To: T10 Technical Committee  
From: Timothy Hoglund, LSI Logic  
Date: 06 January 2004  
Subject: T10/04-036r0 SAS-1.1: AIP clarifications and XL state transition

This proposal seeks to clarify and correct a few expander-related issues present within the current working draft of the SAS 1.1 specification:

**Figure 2 — Missed Transmit Open**

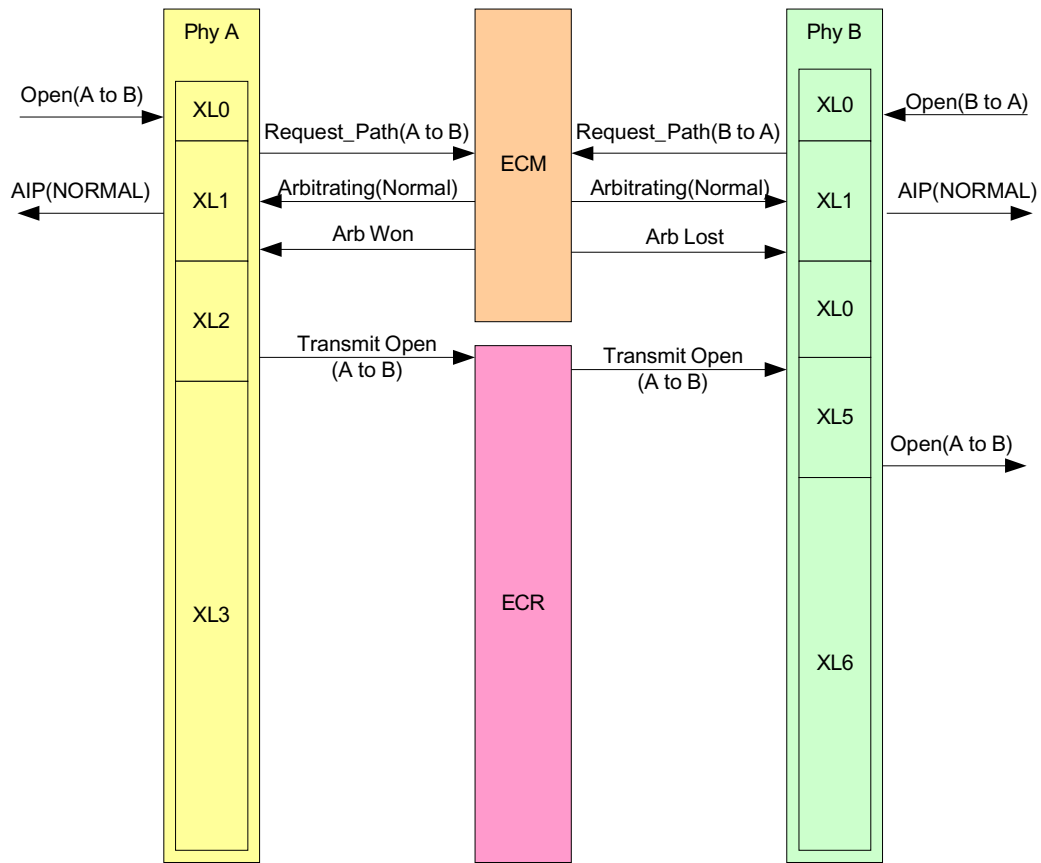
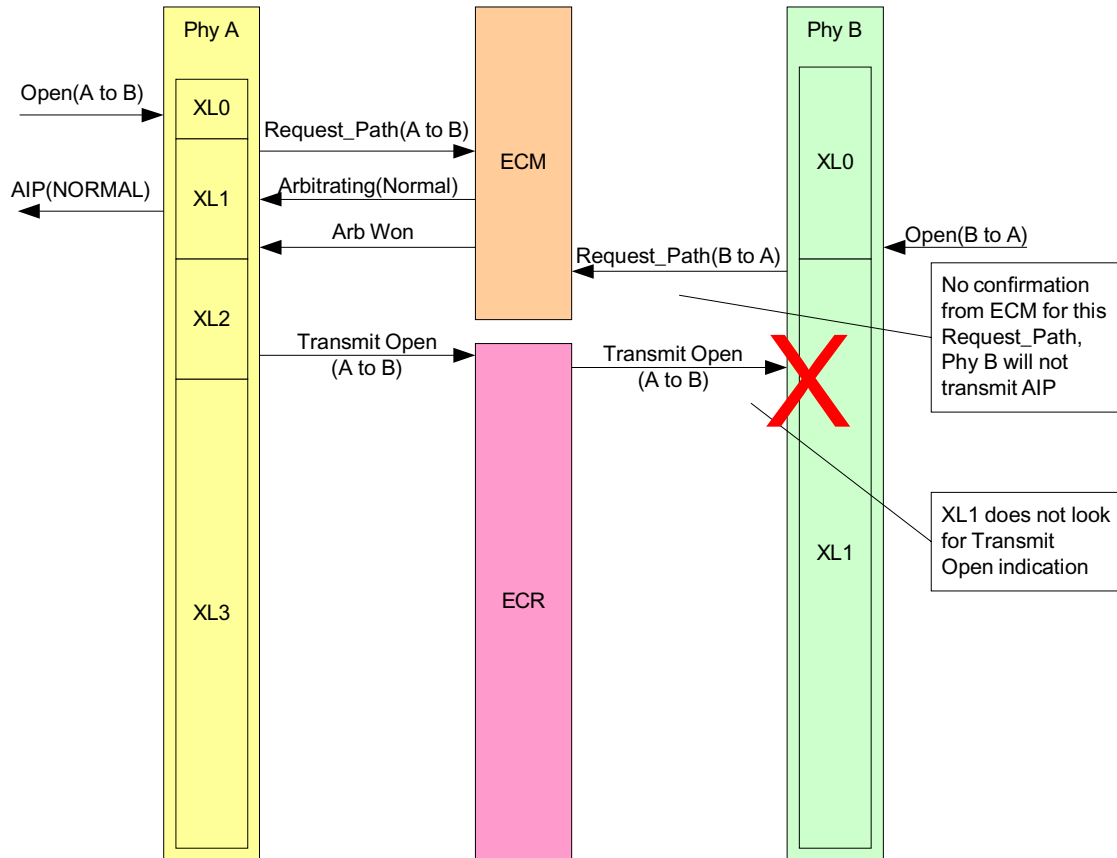
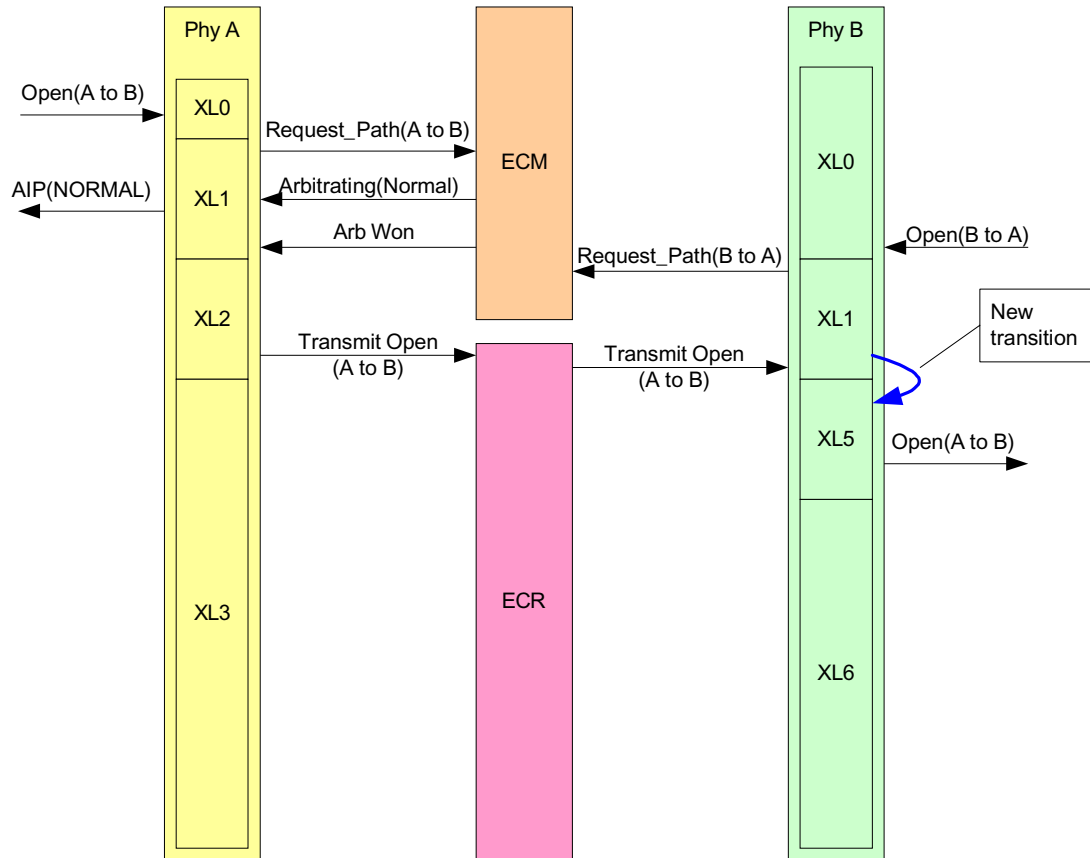
Should two expander phys arbitrate for each other at the same time, the ECM will provide an Arb Won confirmation to one and an Arb Lost confirmation to the other and both phys will properly resolve the situation.

However, a window of misopportunity exists whereby if phy B arbitrates for phy A after phy A has received an Arb Won confirmation, phy B will get stuck in the XL1:Request\_Path state and not detect the Transmit Open indication from phy A.

This proposal calls for the addition of a state transition from XL1:Request\_Path to XL5:Forward\_Open and the passing of an OPEN Address Frame Received argument along with this transition to properly resolve the scenario.

##### 7.15.4.6 Transition XL1:Request\_Path to XL5:Forward\_Open

This transition shall occur if a Transmit Open indication is received and none of the following confirmations have been received:

- a) Arbitrating (Normal);
- b) Arbitrating (Waiting On Partial);
- c) Arbitrating (Blocked On Partial);
- d) Arbitrating (Waiting On Connection);
- e) Arb Won;
- f) Arb Lost;
- g) Arb Reject (No Destination);
- h) Arb Reject (Bad Destination);
- i) Arb Reject (Bad Connection Rate); or
- j) Arb Reject (Pathway Blocked).

This transition shall include OPEN Address Frame Received argument containing the arguments received in the Transmit Open indication.

Figure 90 — XL (link layer for expander phys) state machine (part 1)

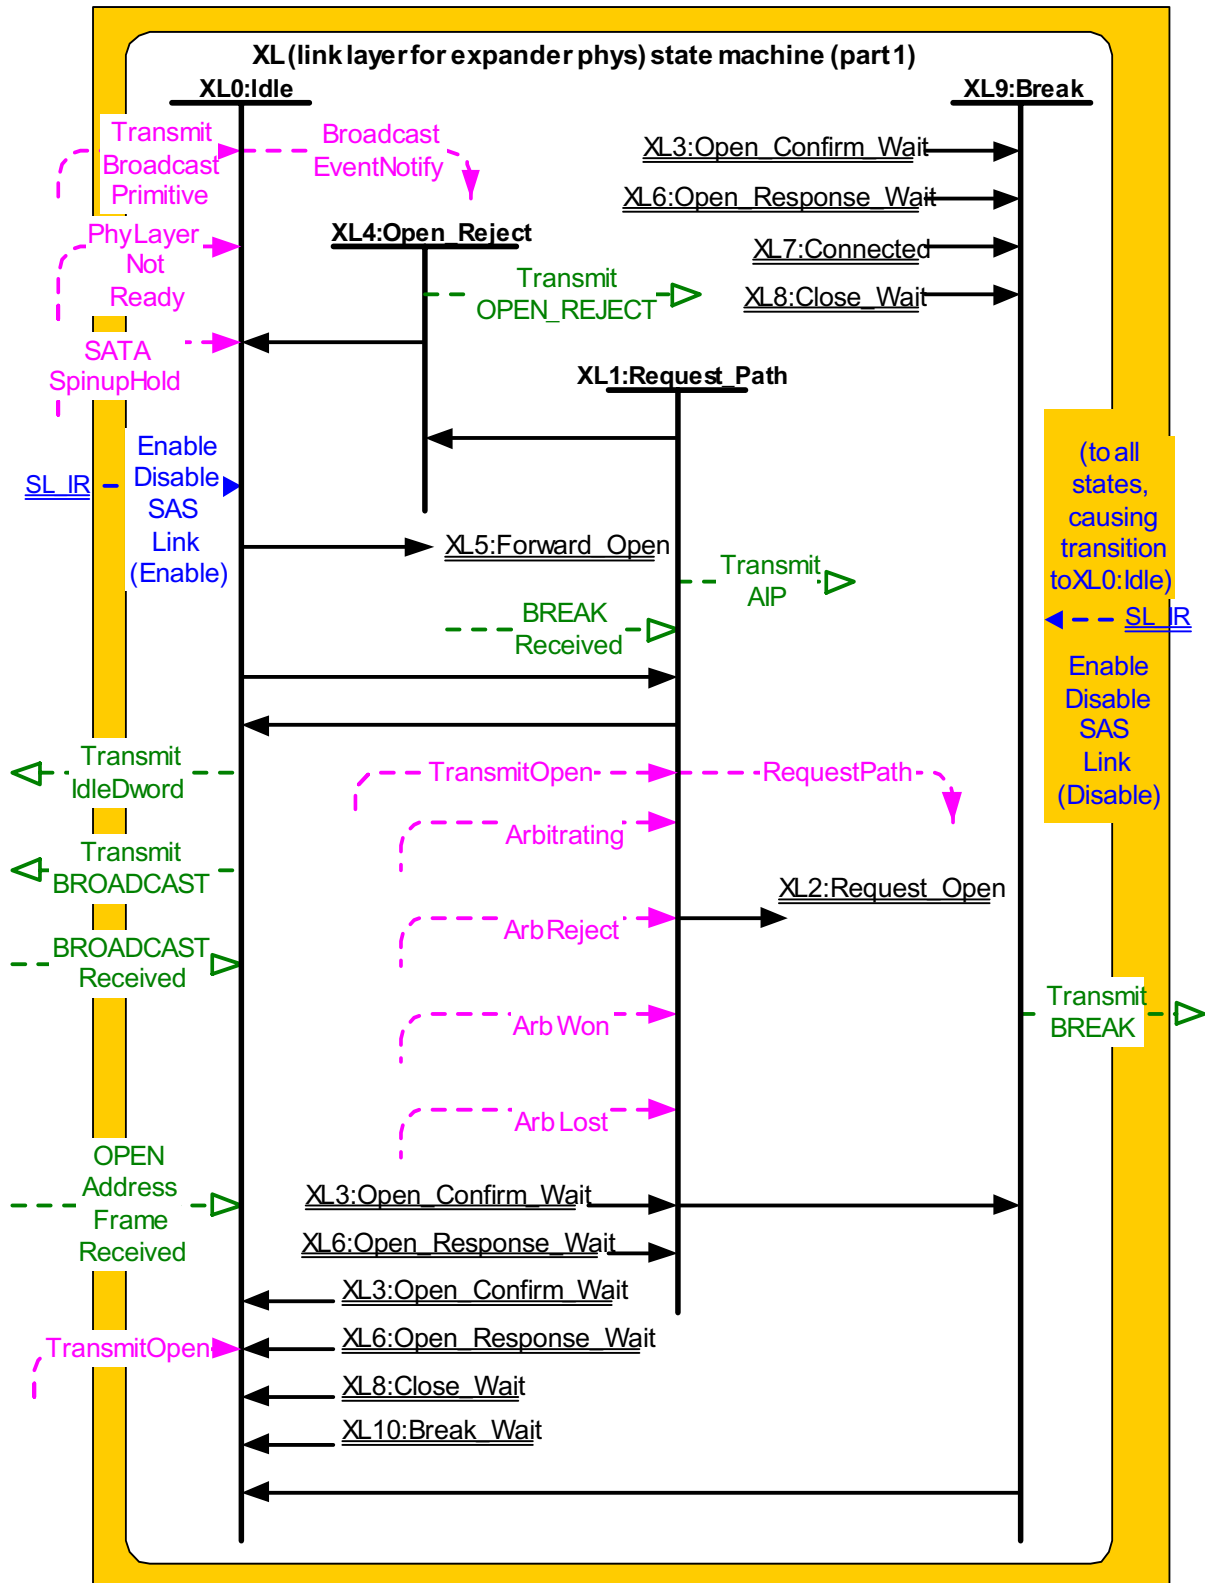
Figure Figure 90 — shows several states in the XL state machine.

Figure G.4 — Connection request - OPEN\_REJECT by expander device

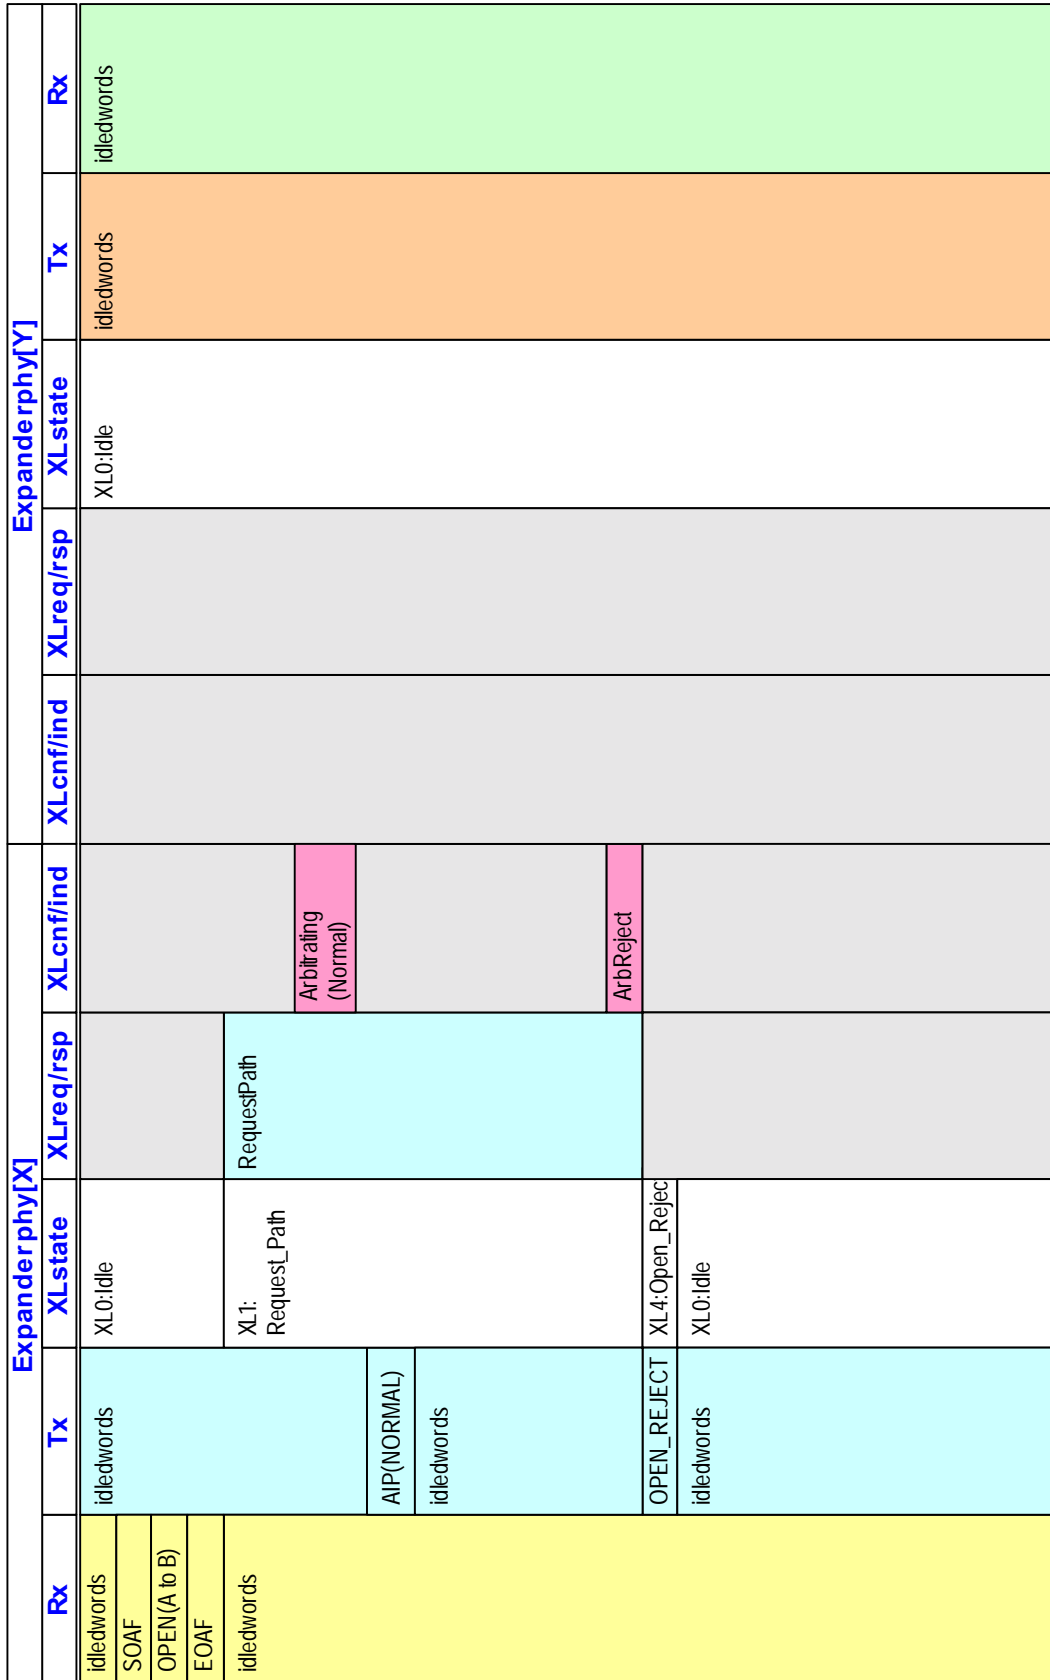
## 5. Update Annex G diagrams based on above changes.

This proposal includes recommended changes to Annex G diagrams in accordance with the suggested normative changes outlined above and detailed below.
